## REVISED RESPONSE TO REQUEST FOR ADDITIONAL INFORMATION

### APR1400 Design Certification

Docket No. 52-046

**RAI No.:** 252-8299  
**SRP Section:** 03.07.02 – Seismic System Analysis  
**Application Section:** 3.7.2  
**Date of RAI Issue:** 10/19/2015

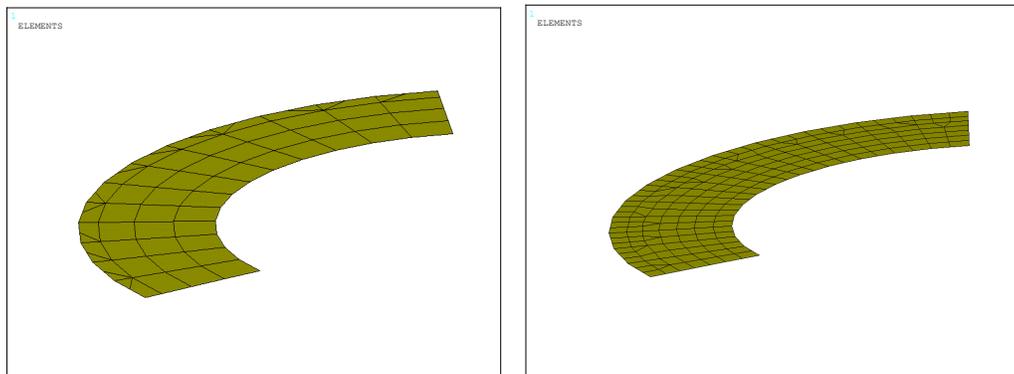
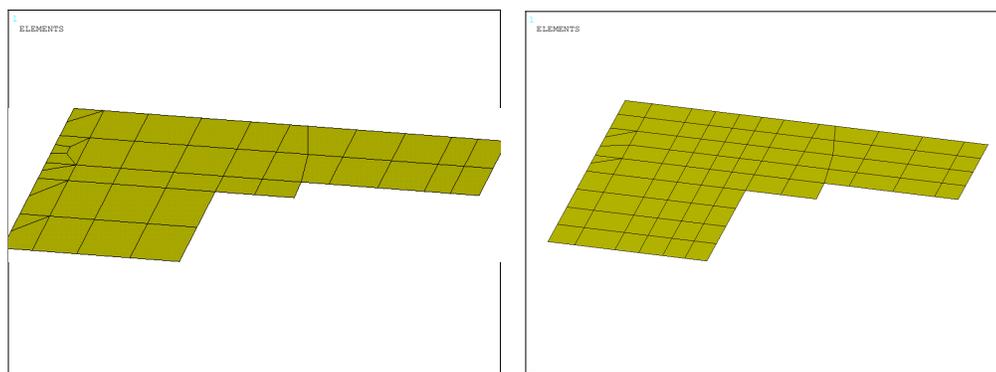
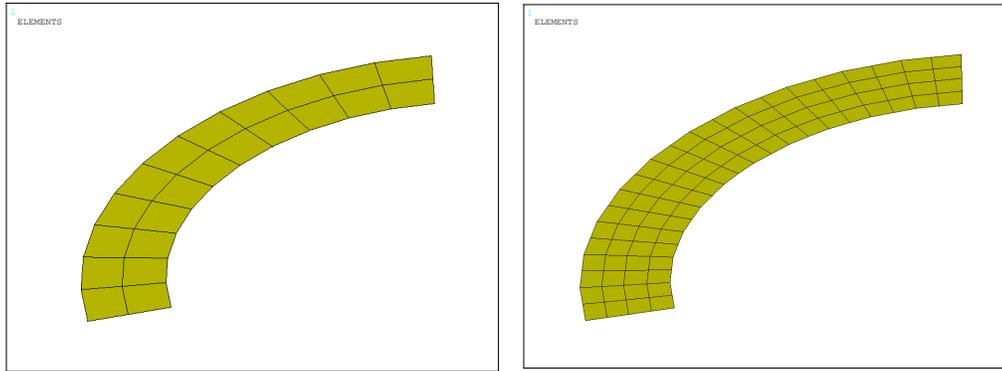
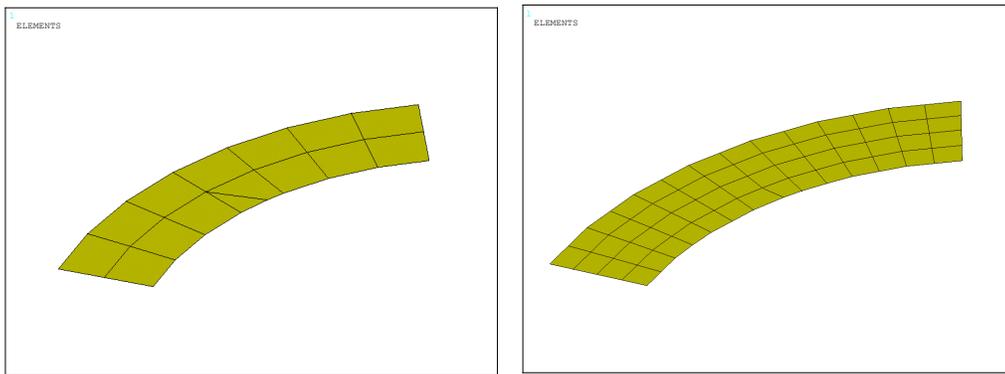
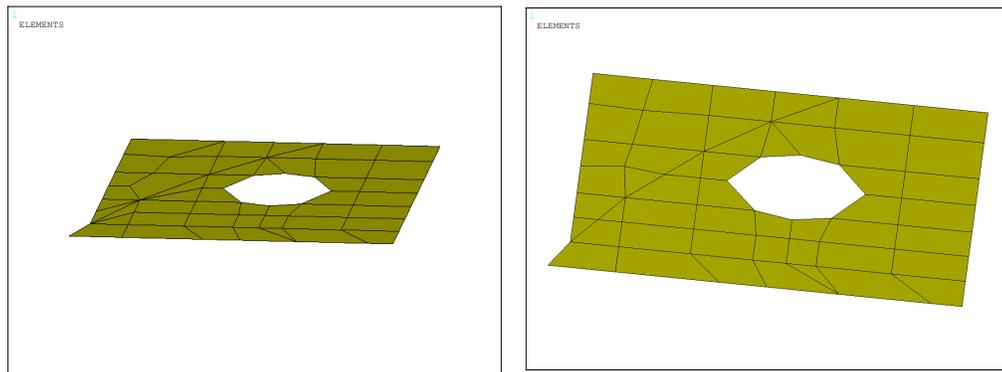
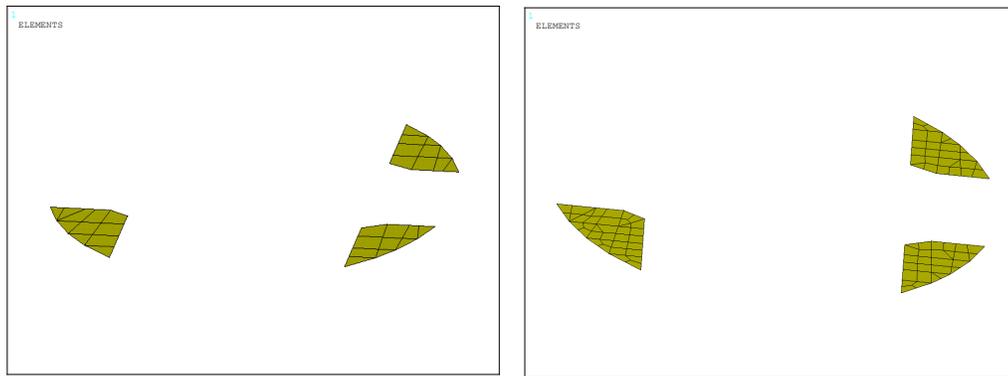
b) Representation of Floor Loads, Live Loads, and Major Equipment in Dynamic Model

SRP Section 3.7.2.II.3D provides the acceptance criteria regarding the representation of floor loads, live loads, and major equipment in a dynamic model. In addressing these SRP criteria, DCD Section 3.7.2.3.3 includes a description of masses that are assumed to contribute to the inertial forces in the seismic analyses. However, this DCD section did not specify the magnitude of such masses. For example, based on the description in DCD Section 3.7.2.3.3, it could be inferred that 100% of the live load is used in the seismic load case. The staff review finds that Section 3.2.5 and Table 4-7 in APR1400-E-S-NR-14002-P,

Except for the slabs between the SSW and the CS described above, all other slabs in the RCB are modeled in the seismic analysis model of the RCB. The figures and the fundamental frequencies of those slabs in the coarse mesh and fine mesh RCB models are presented in Figures 1 through 6 and Table 1. The average mesh sizes of the coarse and fine slab models are approximately 5 ft x 5 ft and 10 ft x 10 ft, respectively. As shown in Table 1, the fundamental frequencies of the fine mesh slab models are higher than 50 Hz. The fundamental frequencies of the coarse mesh slab models are similar to the fine mesh slab models. These results indicate that most of the slabs that are modeled in the seismic analysis model of the RCB are quite rigid, and the mesh size of slabs in coarse mesh model is sufficient to accurately capture the out-of-plane flexibility of the slabs.

Figure 16. Tapered Section in Primary Shield Wall

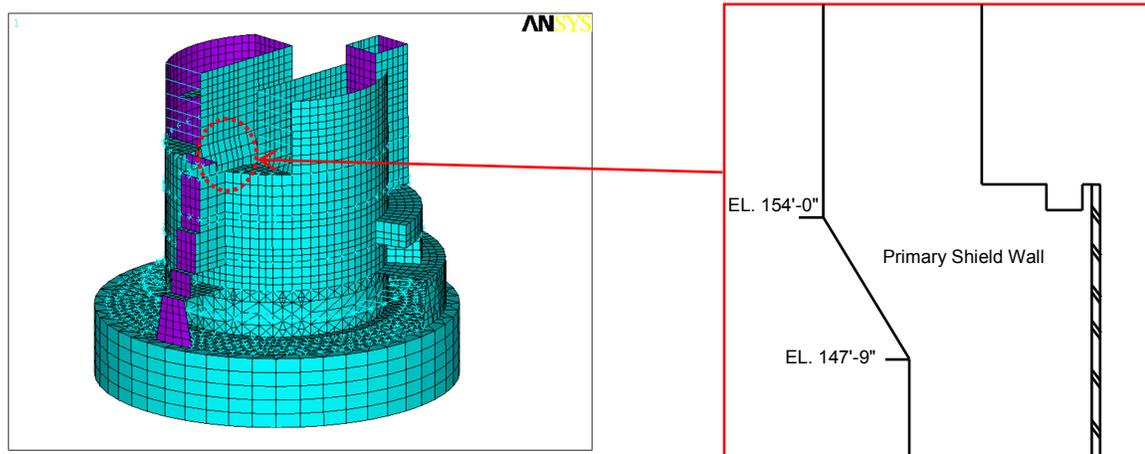
c) Shell Elements in Primary Shield Wall

As described in Section 3.2.10 and shown Figure 3-3 in APR1400-E-S-NR-14002-P, shell elements are used to model the shield wall portion of the primary shield wall (PSW) from EL 130' to EL 191.' Given the geometry of the PSW, the use of thick shell elements may be more appropriate for this portion of the PSW. he geometry of the PSW, the use of thick shell elements may be more appropriate for this portion of the PSW. Additionally, based on Figure 3-3, a portion of these walls modeled with shell elements, appears to be not in plane with respect to the plane of each respective wall. Therefore to assist the staff in evaluating the adequacy of the FEM for the PSW, the staff requests the applicant to clarify why the shell element selected for the PSW model is appropriate as opposed to using a thick shell element formulation. Additionally, please describe the modeling approach and the basis of the shell portion of the walls including the location of plates oriented in non-parallel planes.

The thickness and center axis of the PSW section are changed over EL. 147'-9" through EL. 154'-0", as shown in Figure 16. The portion of wall which is not in plane with respect to the plane of respective walls in Figure 3-3 of APR1400-E-S-NR-14002-P was intentionally modeled to represent the contour of the PSW.

Figure 17. Connection between RCS Supports and Solid Elements

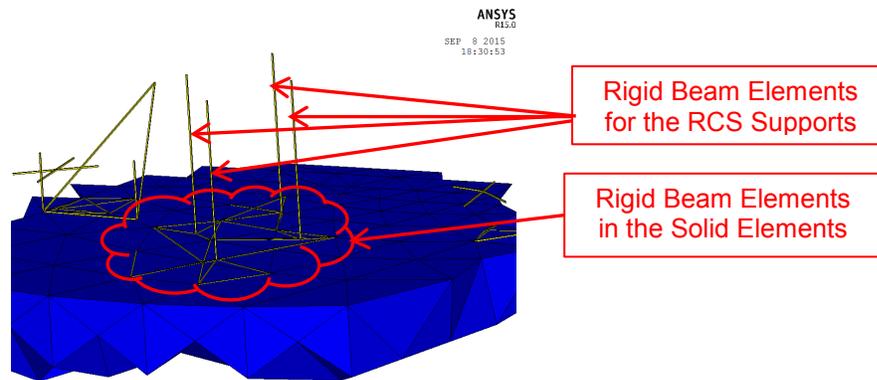
d) Transitions between Beam and Solid Elements

Staff review of APR1400-E-S-NR-14002-P finds that the nuclear island finite element model includes locations at which beam elements connect with solid elements (e.g. connections between the reactor coolant system model and the containment internal structure model). However, the staff did not find a description of how the degree of freedom compatibility is addressed for transitions between beam and solid elements. Therefore the staff requests the applicant to provide such description, including a graphical representation of the transition between beam and solid elements.

Figure 17 shows the connection between the RCS supports (rigid beam) and the building model (solid elements). Technical report APR1400-E-S-NR-14002-P will be revised, as indicated in Attachment 3 to this response to incorporate the description of the beam-to-solid element connection.
